Staff Report – Board of Zoning Appeals

Docket #:	BZA2024-005 Development Standard Variance	Hearing Date:	March 25, 2024
Applicant:	Ultra Steak Inc., 13099 Parkside Drive, Fishers, 46038		
Owner:	Wal-Mart Real Estate Business Trust, PO Box 8050, Bentonville, AR 72712		
Subject Property:	1133 N. Emerson Avenue		
Staff Contact:	Gabe Nelson, nelsong@greenwood.in.gov, 317-887-5230

ASPEN CREEK GRILL
PC2023-058

SITE PLAN

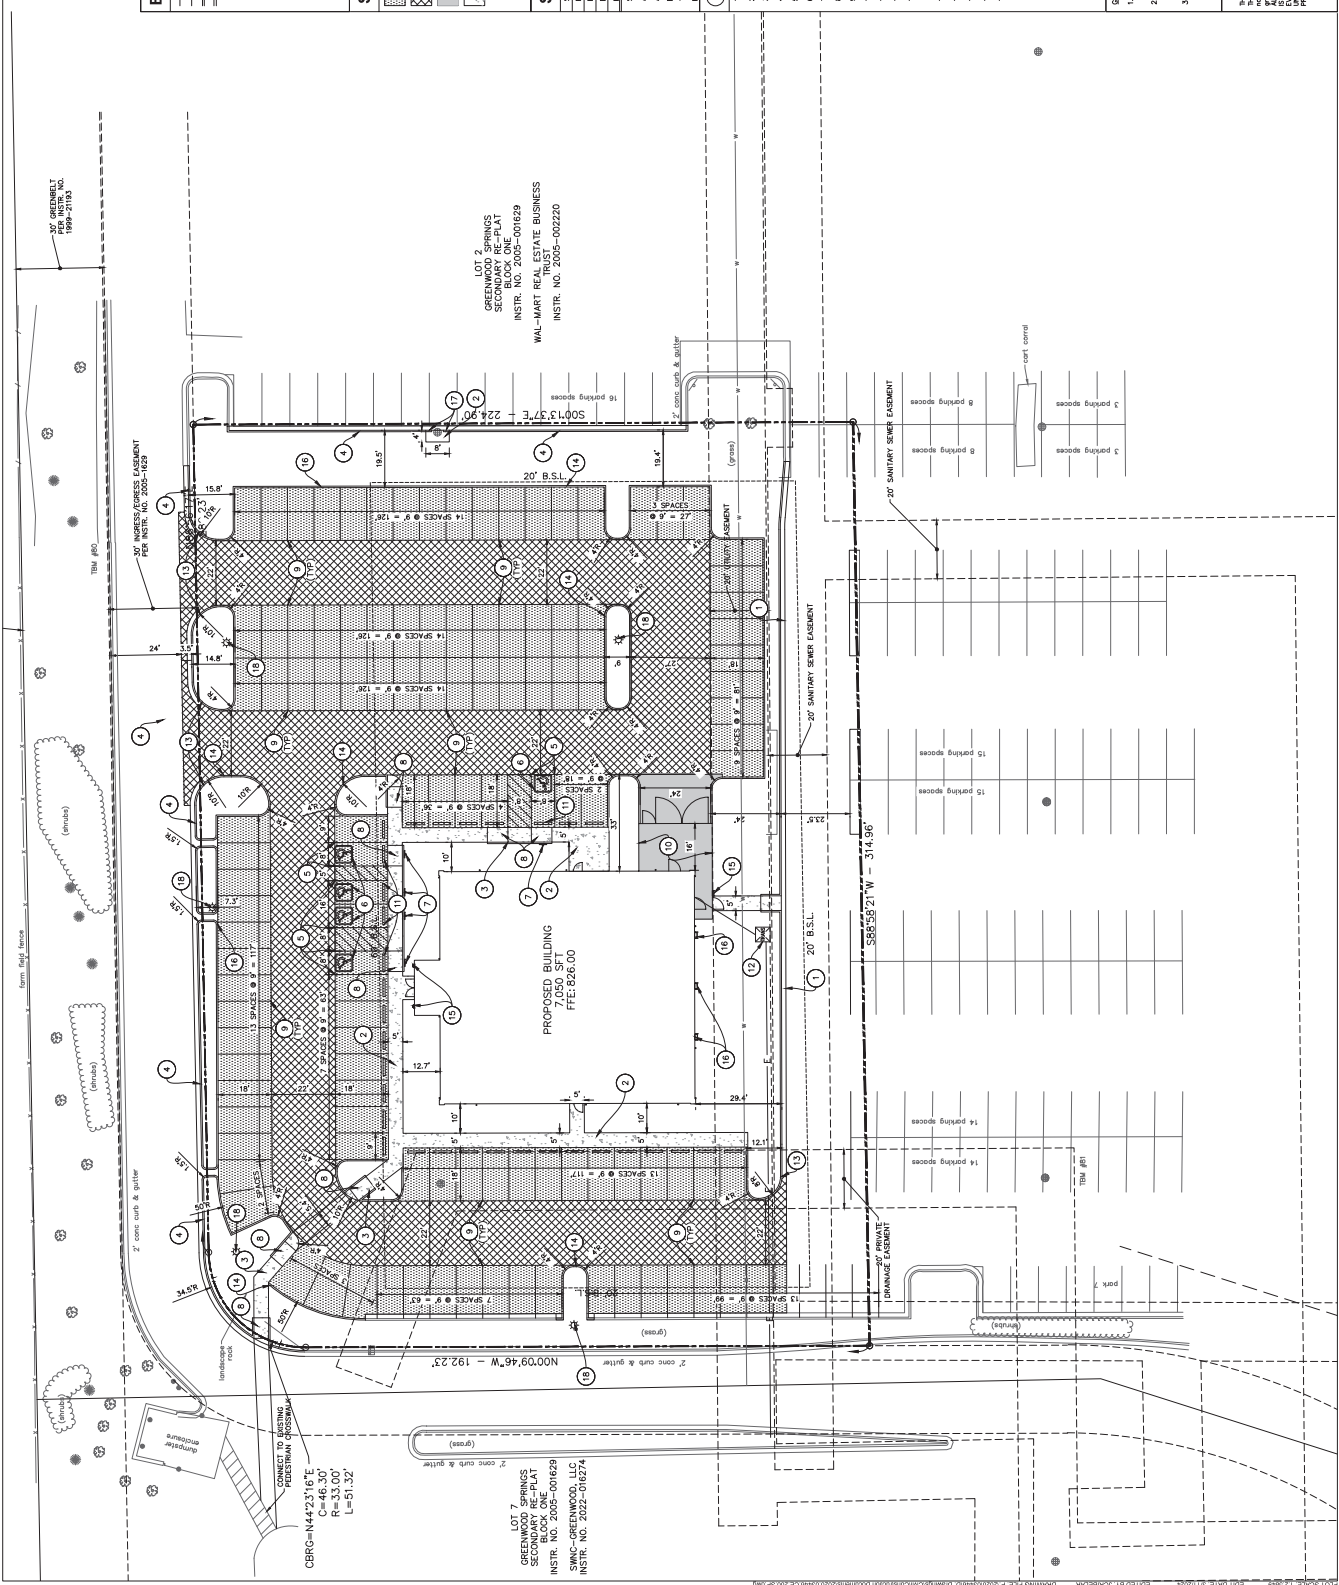
VARIANCE #1: To increase the maximum allowed lot coverage from 70% to 80%

Staff Comment: Staff agrees with petitioner's statement. The development will be an overall increase in greenspace and landscaping, which will increase the general welfare of the area.

Staff will be providing a favorable recommendation to decrease the required amount pervious surface. While the site may not meet current standards in terms of pervious space, it present a compelling case for approval due to

the net increase in pervious space, bring it closer to our requirements than its current condition. Due to the existing site conditions and limited area of parking Staff finds that this site has a practical.

1. The final plans shall substantially conform to the elevations depicted in Exhibit D and the site plan depicted in Exhibit E
